AGENDA
La Vergne Planning Commission
September 26, 2023 at 6:00 PM

MINUTES OF THE REGULAR MEETING OF THE CITY OF LA VERGNE PLANNING COMMISSION HELD ON AUGUST 29, 2023 AT LA VERGNE CITY HALL, LA VERGNE, TENNESSEE.

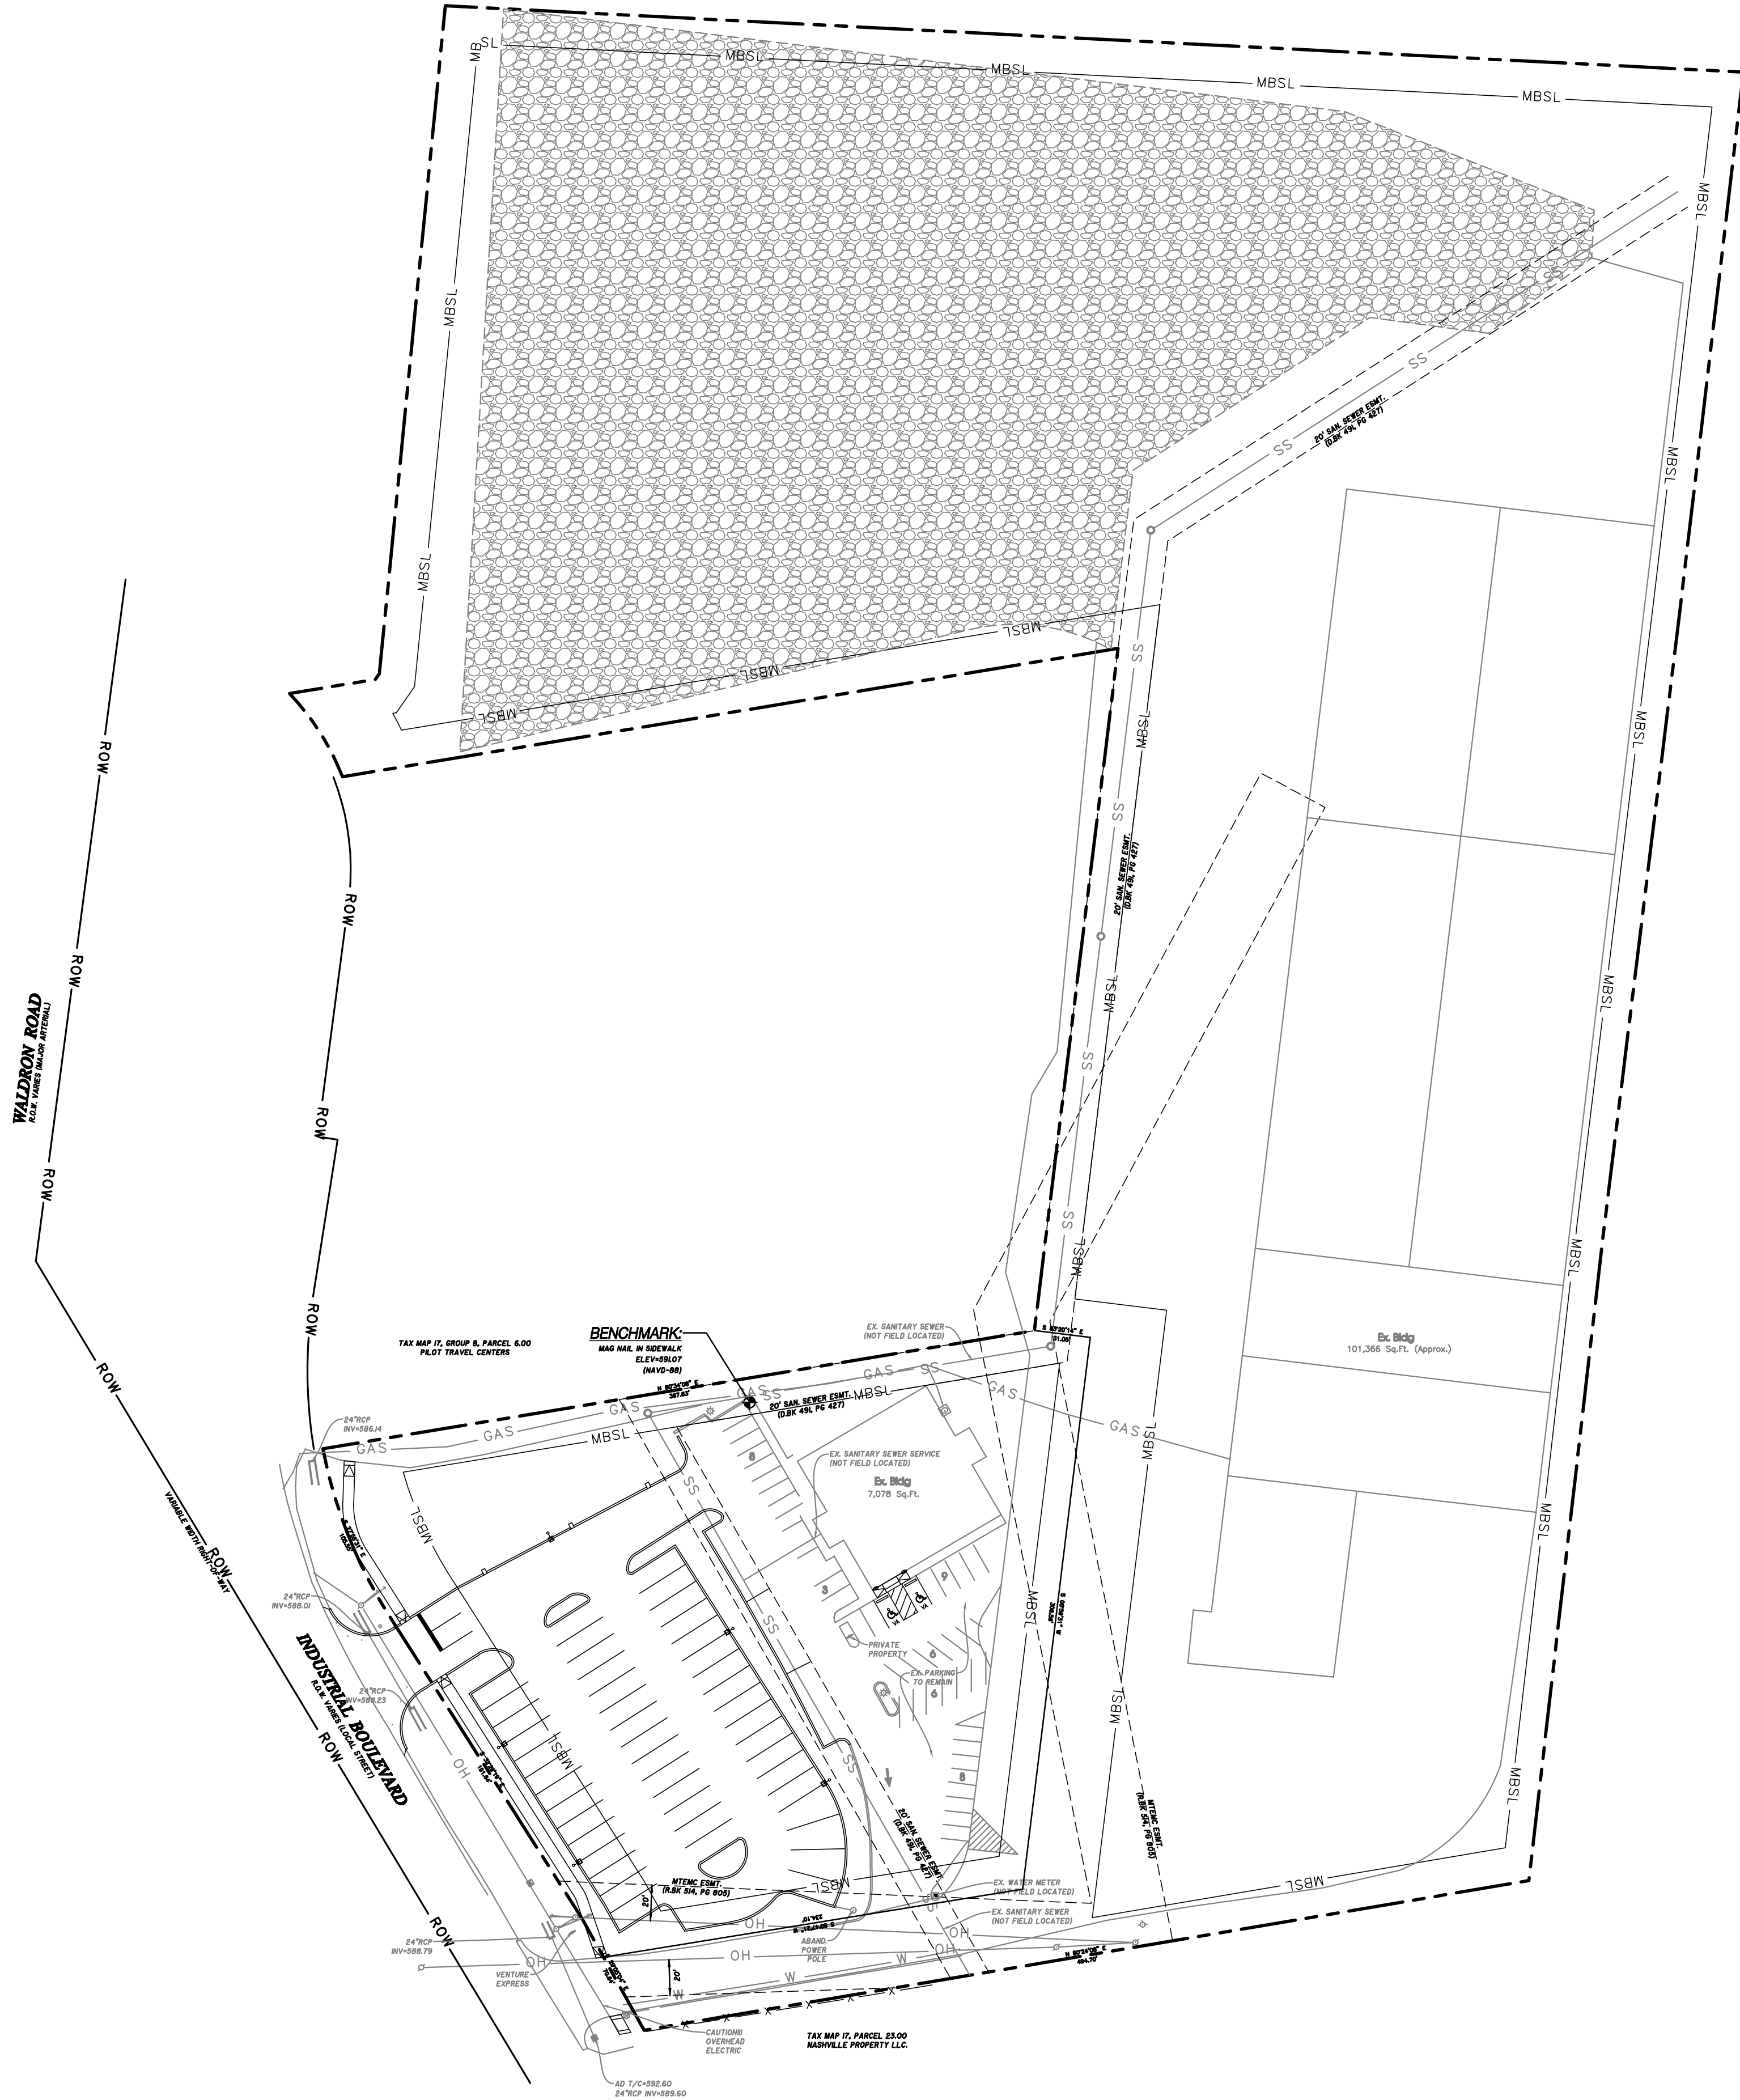
4. (Sheet C2.0) Show distance from nearest point of new parking area to north property line.
5. (Sheet C2.0) Show distance from driveway to north property line.
6. **(Sheet C2.0) Proposed sidewalk is shown on private property. Add public access easement or move to right-of-way. Coordinate with City Planner.**
7. (Sheet C2.0) Show transformer pad location.
8. (Sheet C2.0) Confirm whether existing gas service will remain.
9. **(Sheet C2.0) Confirm whether existing water and sewer services are to remain. Get with Scott Tatalovich regarding whether upgrades are required to meet current standards.**
10. (Sheet C3.0) Grades on proposed sidewalk show far too much cross slope.

L2.0

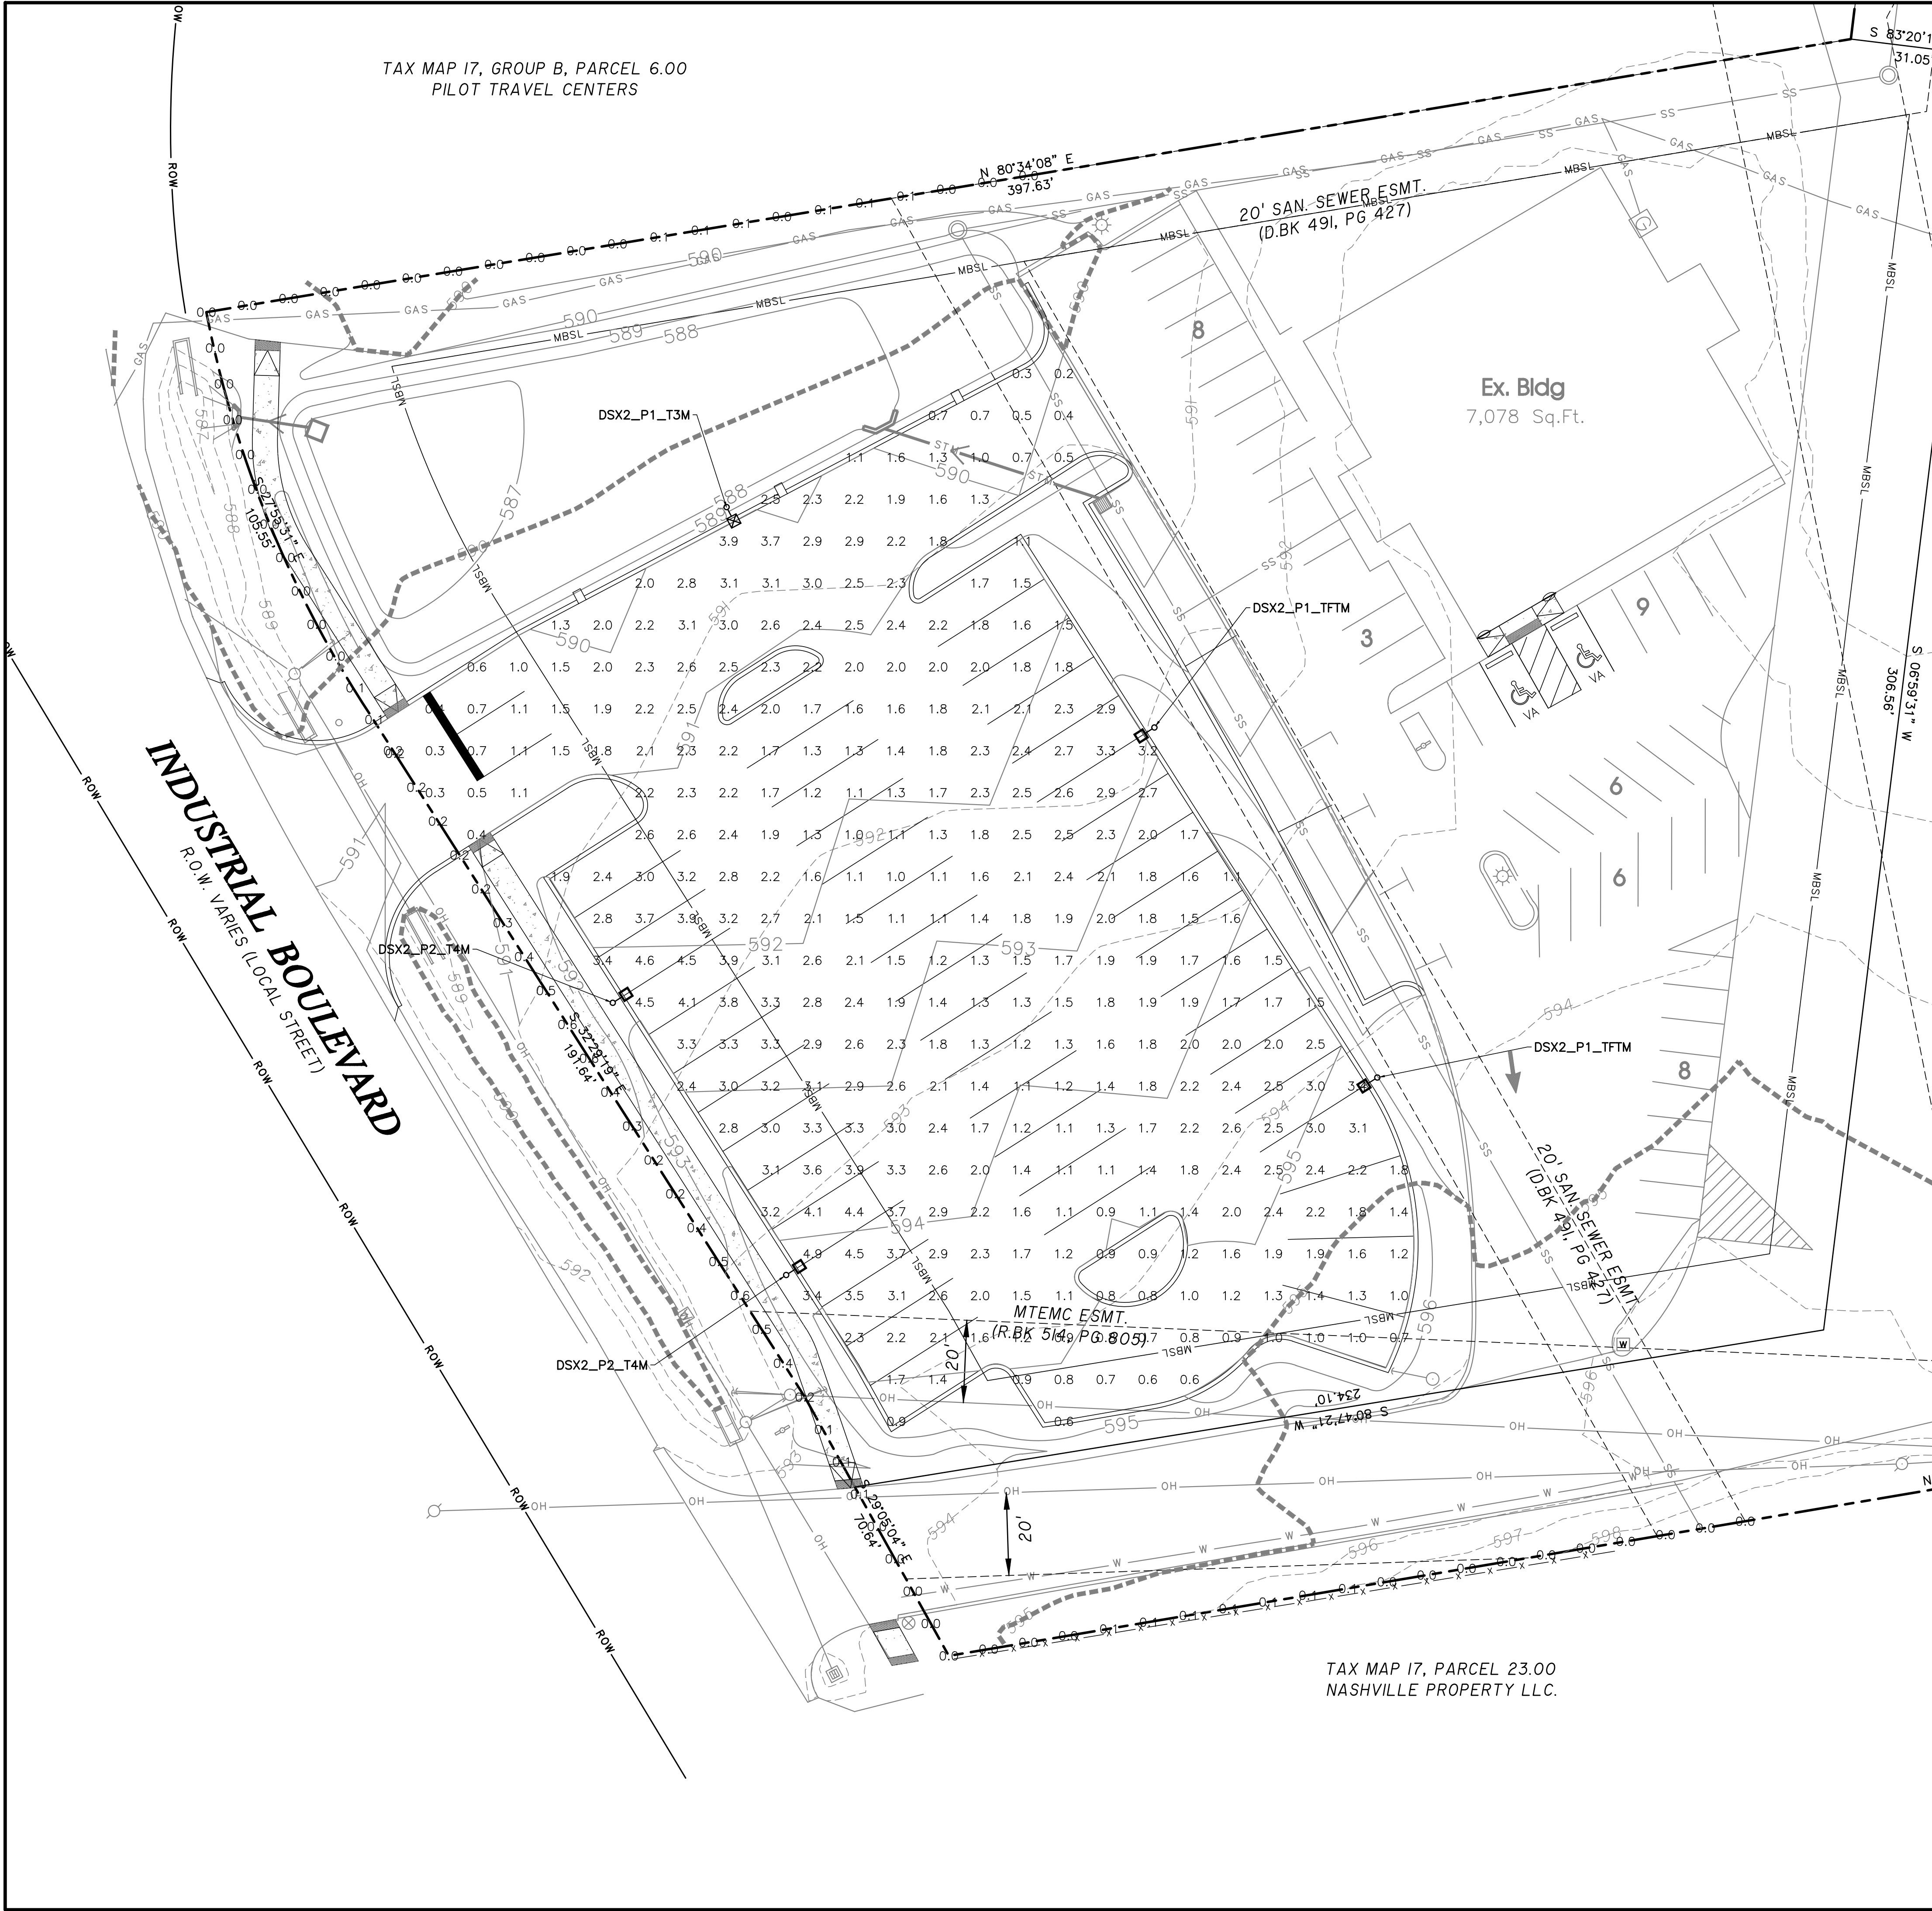
- 8) Install bollards, protective curb and gutter, and/or traffic rated lids around existing water meters, and sewer cleanouts, as needed.
- 9) Do not install trees directly over sewer line (as per current landscape plan, Sht L1.0). Tree roots are very invasive to sewer lines and will eventually break the pipe joints.
